Premise Australia Pty Ltd

RESPONSE TO REQUEST FOR ADDITIONAL INFORMATION 2 – DA 240159

Premise have prepared this letter on behalf of ACEnergy Pty Ltd to respond to a request for additional information (RFI) issued by Yass Valley Council on the 18th of February 2025. The request is made in respect of development application reference number 240159 and relates to the proposed development of Murrumbateman Distribution Battery Energy Storage System at a site addressed as 3 Turton Place, Murrumbateman.

PROJECT DETAILS:	MURRUMBATEMAN DISTRIBUTION BESS 3 TURTON PLACE MURRUMBATEMAN, NEW SOUTH WALES 2582 -34.9920, 149.04964
CLIENT DETAILS:	ACENERGY PTY LTD
DRAWING TITLE:	SITE PLAN 2 OF 2

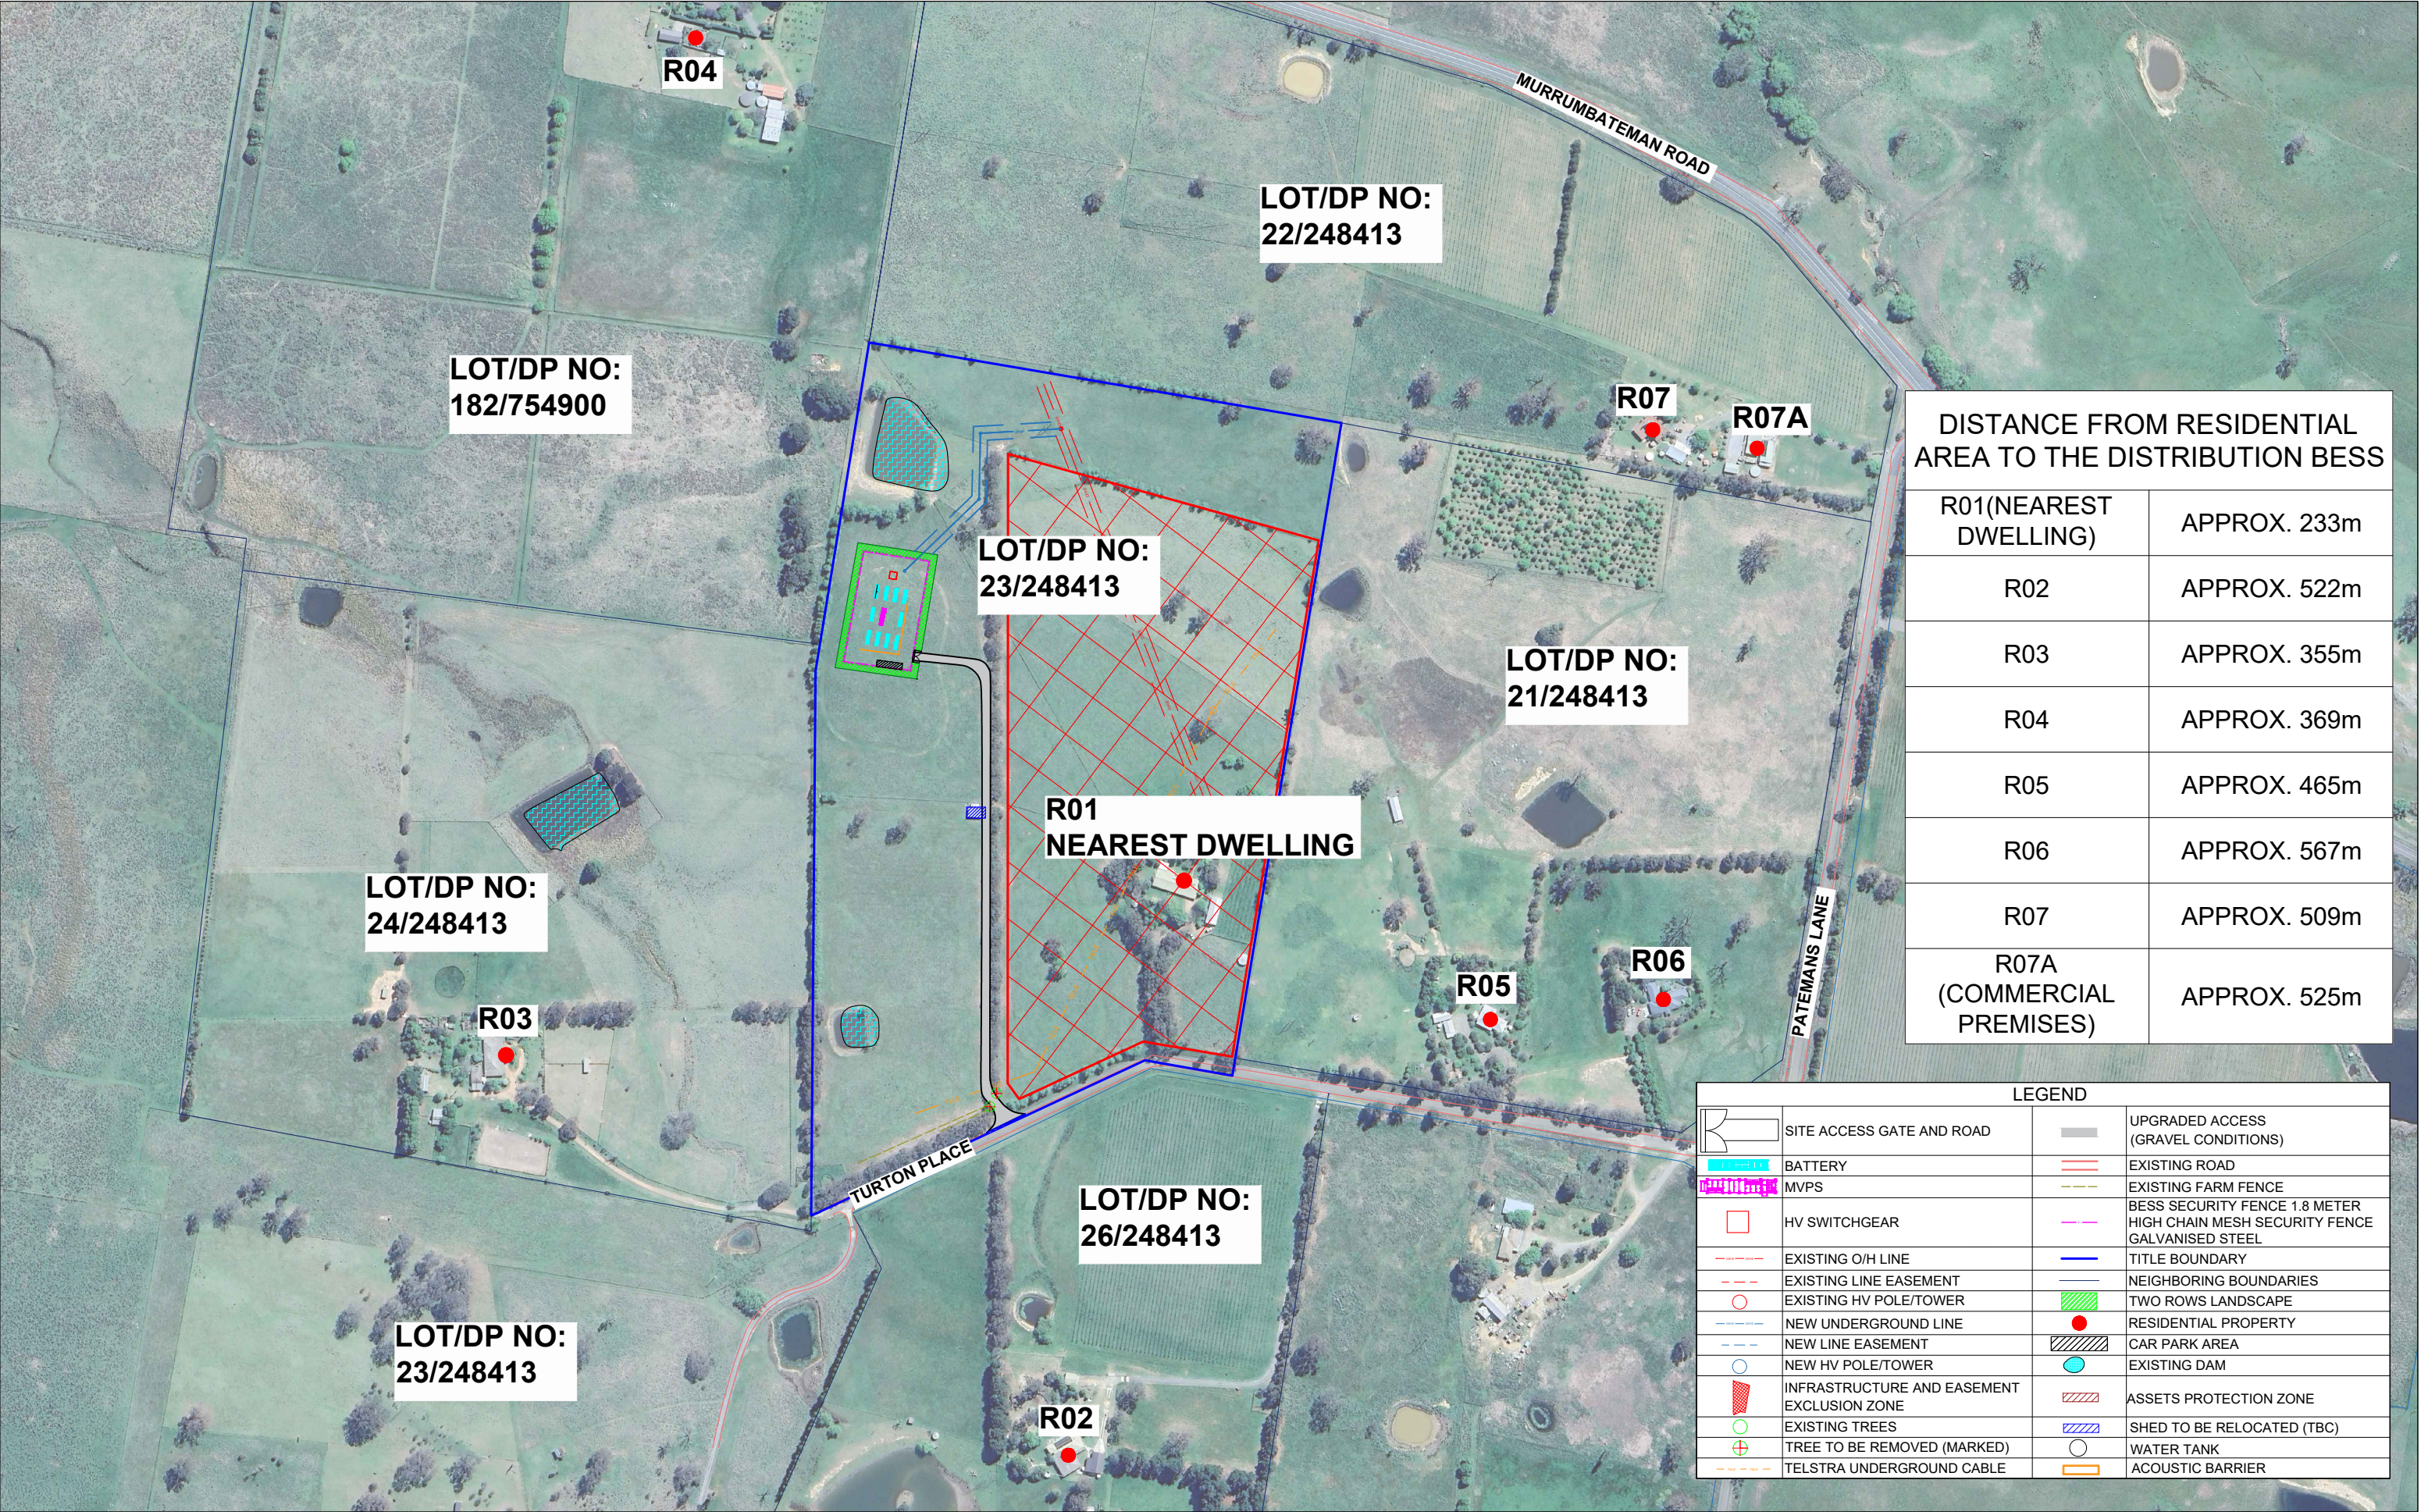
<ul style="list-style-type: none"> <i>Site plan with clear dimensions for lengths and relative setbacks,</i> 	<p>The revised drawing set (Attachment 2) includes an updated site plan to respond to council's request.</p>
<p>3. Materials & Colours</p> <p><i>It is noted in the record of briefing that the Panel considered that visual impacts could be reduced through the use of appropriate materials and colours. In this regard, details of materials and colours are to be provided and should be:</i></p> <ul style="list-style-type: none"> <i>Compatible and sympathetic to the surrounding development.</i> <i>Non-reflective.</i> 	<p>The final selection of project infrastructure, including materials and colour for project infrastructure (e.g., batteries and acoustic products), is dependent on the options available during the finalisation of detailed design and the selection of vendor products for the construction of the project. Where possible, suitable materials and finishes would be implemented to minimise the potential for perceived visual effect, and the longevity of materials and durability of the same. A consent condition for the provision of a final schedule would be a practical measure.</p> <p>The applicant has no objection to a condition of consent requiring the provision of this information to Council's satisfaction prior to issue of a construction certificate.</p>

DISTANCE FROM RESIDENTIAL AREA TO THE DISTRIBUTION BESS	
R01(NEAREST DWELLING)	APPROX. 233m
R02	APPROX. 522m
R03	APPROX. 355m
R04	APPROX. 369m
R05	APPROX. 465m
R06	APPROX. 567m
R07	APPROX. 509m
R07A (COMMERCIAL PREMISES)	APPROX. 525m

PROJECT DETAILS:	MURRUMBATEMAN DISTRIBUTION BESS 3 TURTON PLACE MURRUMBATEMAN, NEW SOUTH WALES 2582 -34.9920, 149.04964
CLIENT DETAILS:	ACENERGY PTY LTD
DRAWING TITLE:	ACOUSTIC BARRIER GENERAL DETAILS (SECTION AND ELEVATIONS)

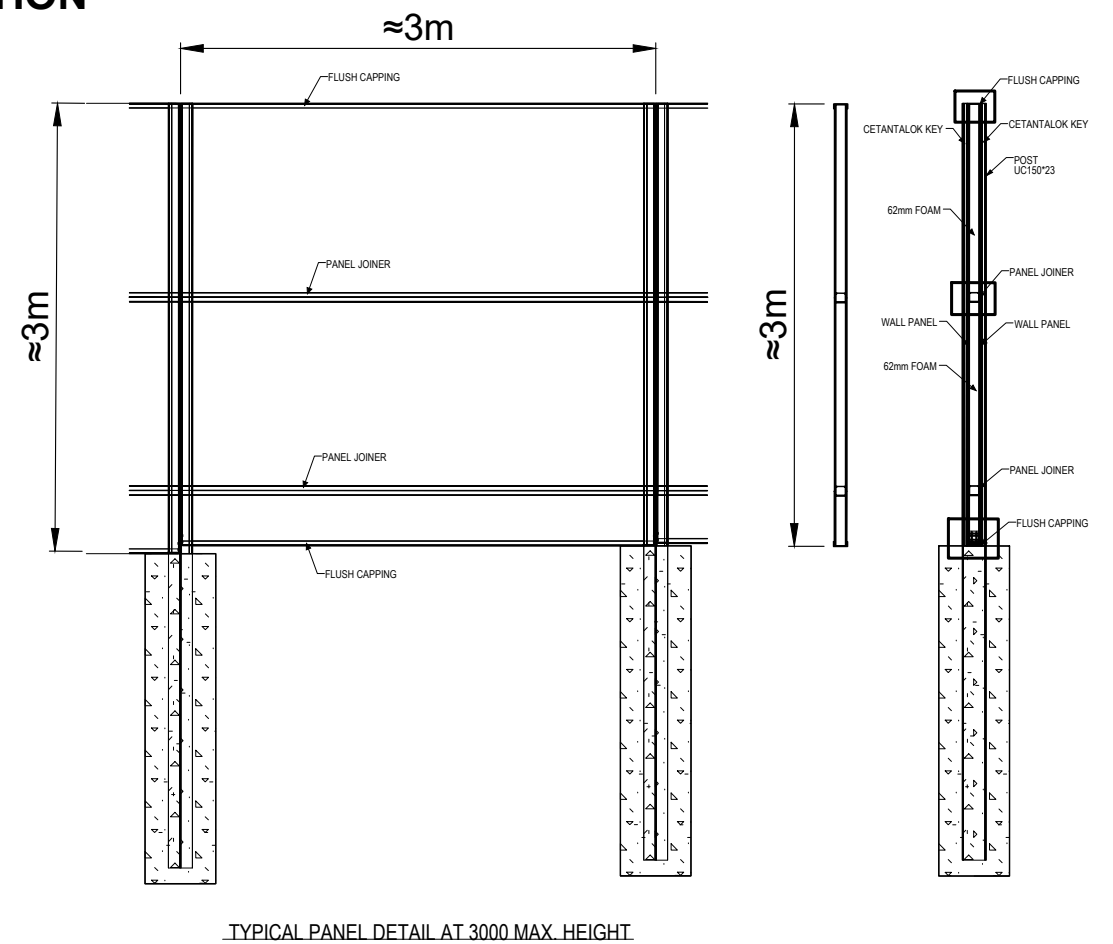
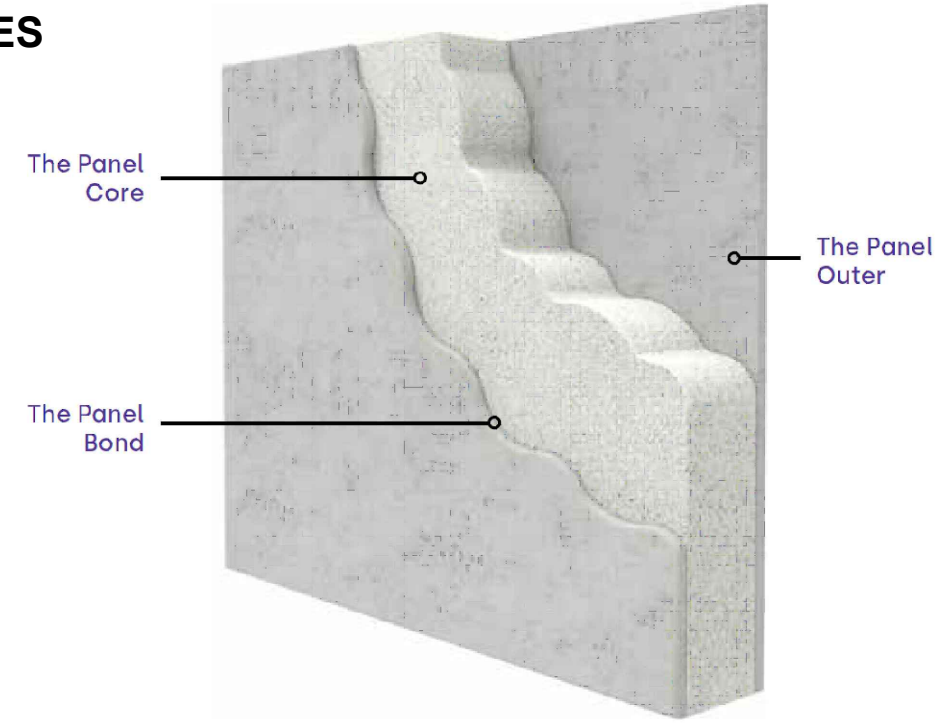
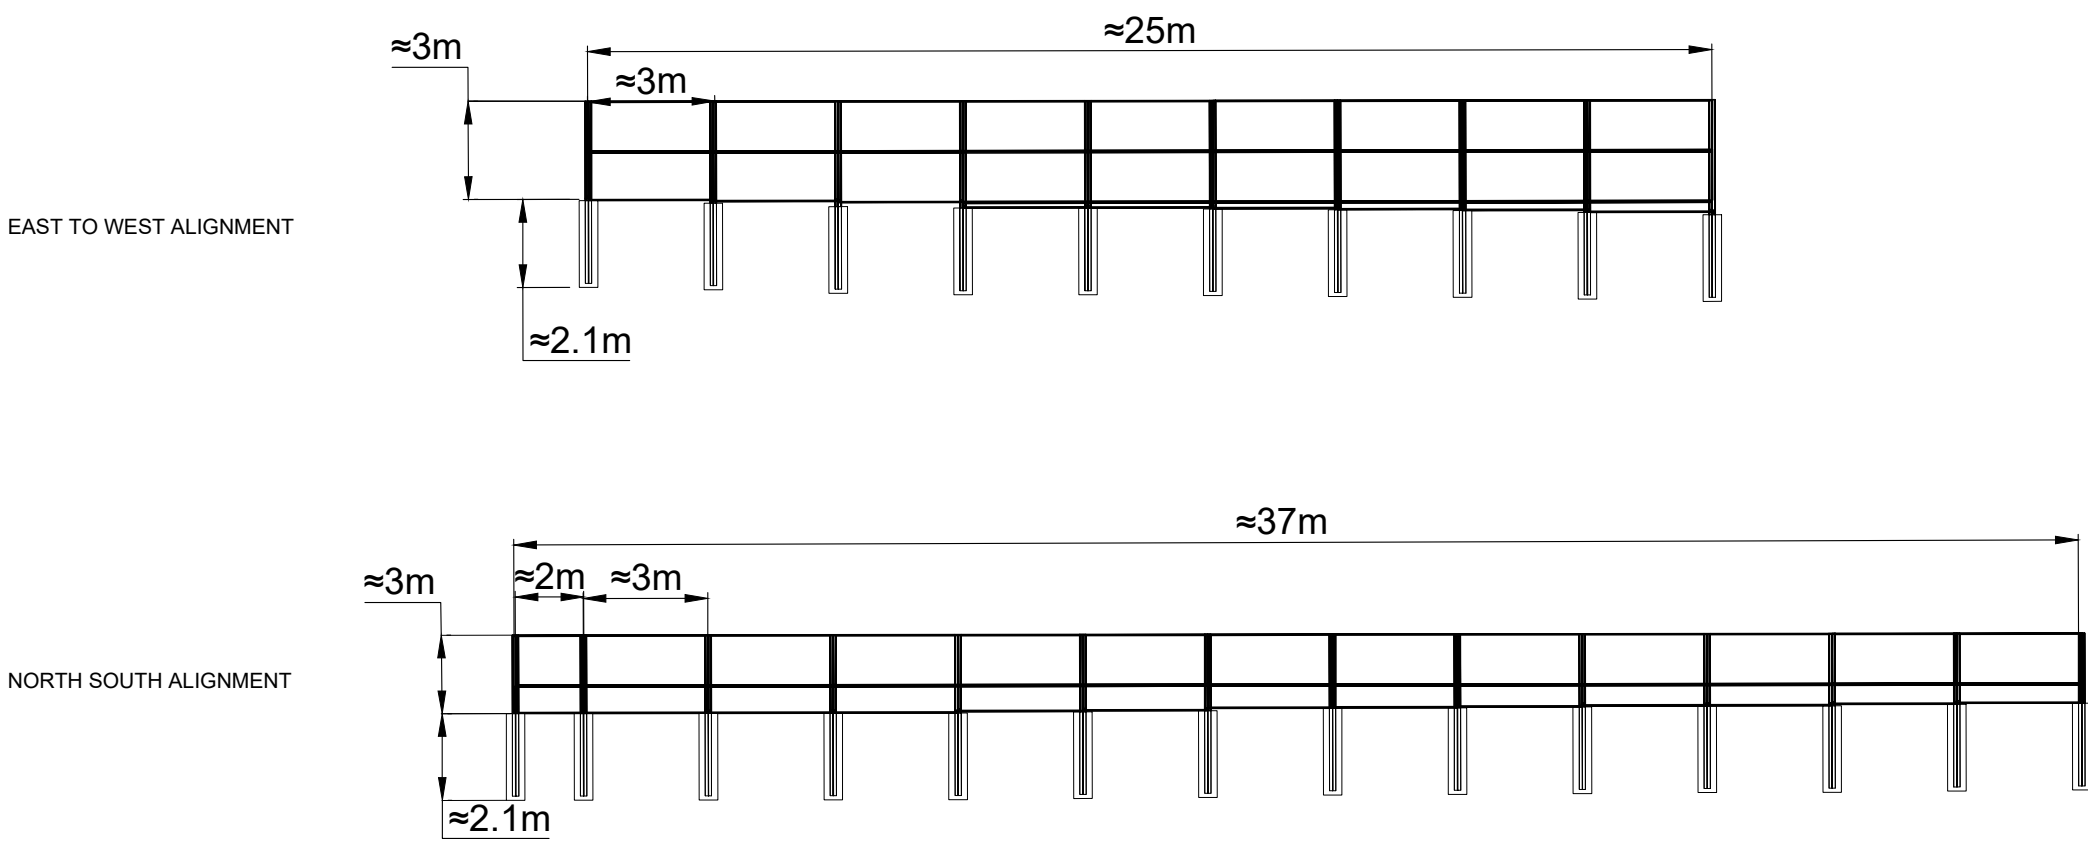
2.	<p>Acoustic Barrier</p> <p><i>The response to additional information request indicates that the revised acoustic report provides an indication of the general specifications for the proposed acoustic barrier, including minimum height of 3000mm and the general surface density. It is considered that there remains insufficient clarity and detail of the acoustic barrier to enable full assessment of this in accordance with s4.15 Environmental Planning and Assessment Act 1979. In this regard, the following information is to be provided:</i></p>	<p>The revised acoustic report (Attachment 3) has provided additional clarification on the construction of the barrier and specifications to ensure suitable materials are selected. The proposed acoustic barrier as specified by the acoustic assessment is to be constructed with:</p> <ul style="list-style-type: none"> A minimum height of 3000mm. Noting that minor increases to the final height may result according to the assembly of panels. A surface minimum weight of 12 kg/m² No gaps between panels and between the panels and the ground below. <p>The acoustic barrier must be lined on the equipment side using sound absorbing materials, and WMG have recommended that:</p> <p><i>“...the absorption coefficient performance of the sound absorbing lining achieve not less than 0.9 at the 3150Hz one third octave band frequency which has been identified as critical to the assessment. The overall NRC performance can be lower, and in the order of 0.7.”</i></p>

- *Separate, dimensioned, elevation drawings of the acoustic barrier, including the maximum height and details of construction type, material, and colours/finishes are to be provided.*
- *Site plan with clear dimensions for lengths and relative setbacks.*

Additional Information Requested	Comments
	<p>From experience WMG detail that a suitable material for external applications may include Megasorber faced with Soundmesh G8 facing. The technical specification sheet for the Soundmesh G8 facing material and other soundproofing products are available via Megasorber's website.</p> <p>The final selection of soundproofing products is subject to the finalisation of design. Several options, however, are available and are capable of being designed to achieve the requirements of the project.</p> <p>The applicant has no objection to a condition of consent requiring the provision of this information to Council's satisfaction prior to issue of a construction certificate.</p>
<ul style="list-style-type: none"> <i>Separate, dimensioned, elevation drawings of the acoustic barrier, including the maximum height and details of construction type, material, and colours/finishes are to be provided.</i> 	<p>A revised drawing set, including details of the proposed acoustic barrier, is provided as Attachment 2. This includes a typical section of the proposed barrier, features of the material proposed and elevations.</p> <p>As noted, final details on the construction type, material, colours and finishes of acoustic products are contingent on the selection of vendors during the detailed design stage. Megasorber's website, however, provides example specification sheets for suitable acoustic products which include dimensions of panels, acoustic properties and options for colours and finishes.</p>

To provide noise reduction qualities, the barrier must be constructed of materials with a surface minimum weight of 12 kg/m² and be constructed with no gaps between panels and between the panels and the ground below.
